Development Review Committee  
Government Center Complex Conference Room, Building A  
January 31, 2007 - 4:00 p.m.

**DEVELOPMENT REVIEW COMMITTEE ACTIONS REPORT**  
**01/31/07**

**SITE PLAN 150-04. Abe's Mini-Storage**  
**Staff Report for the January 31, 2007, Development Review Committee Meeting**

**ENVIRONMENTAL DIVISION REVIEW COMMENTS**  
**ABE'S MINI-STORAGE**  
**COUNTY PLAN NO. SP – 150 - 04**  
*January 23, 2007*

Water Data Sheet:

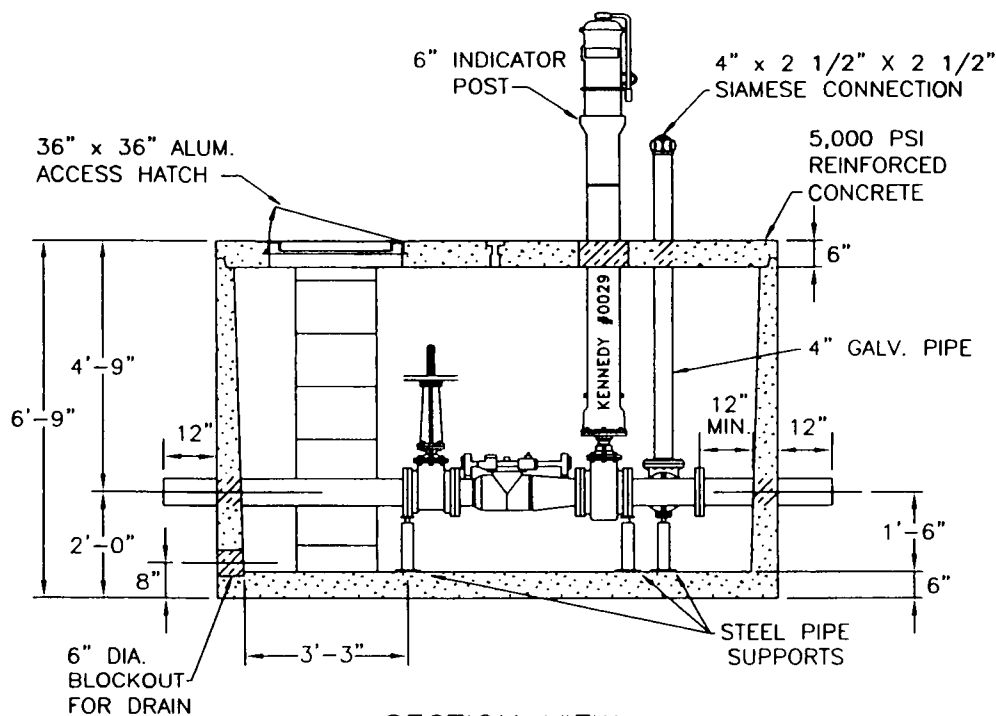
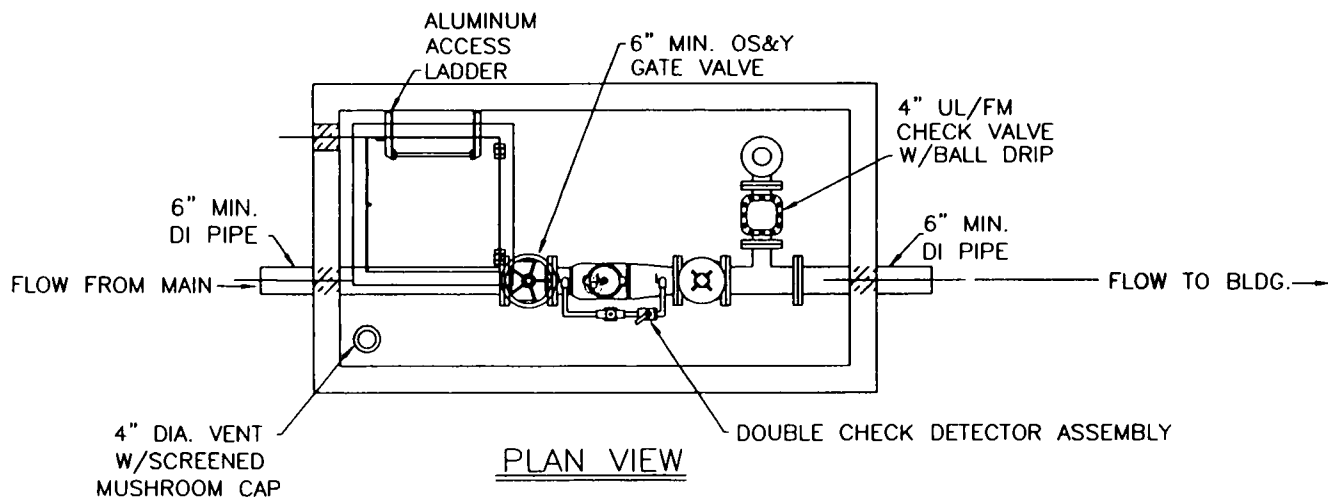
1. *Section 5: Area listed for office warehouse space appears not to reflect the site plan. Verify and revise accordingly.*
2. *Section 5b: Flow listed needs to be based on the IPC' calculations (divided by 4 to yield Average Day Domestic). Revise accordingly.*

3. *Section 5e and 5h: As previously noted and verified by the data listed, the 2,500 gpm at 20 psi cannot be supplied to the site according to the hydrant flow test data submitted (1264 @20 psi). The Applicant shall verify that the proposed 8-inch line size will provide the 2500 gpm required or provide calculations with an approval letter from JCC Fire Department which justifies a reduction in the fire flow requirements for this development.*
4. *Section 6: The pipe material listed is not permitted by JCSA for use in waterlines. Revise to either reflect PVC or DIP.*
5. *Section 8: Annotate the 2 fire hydrants as being "Private".*
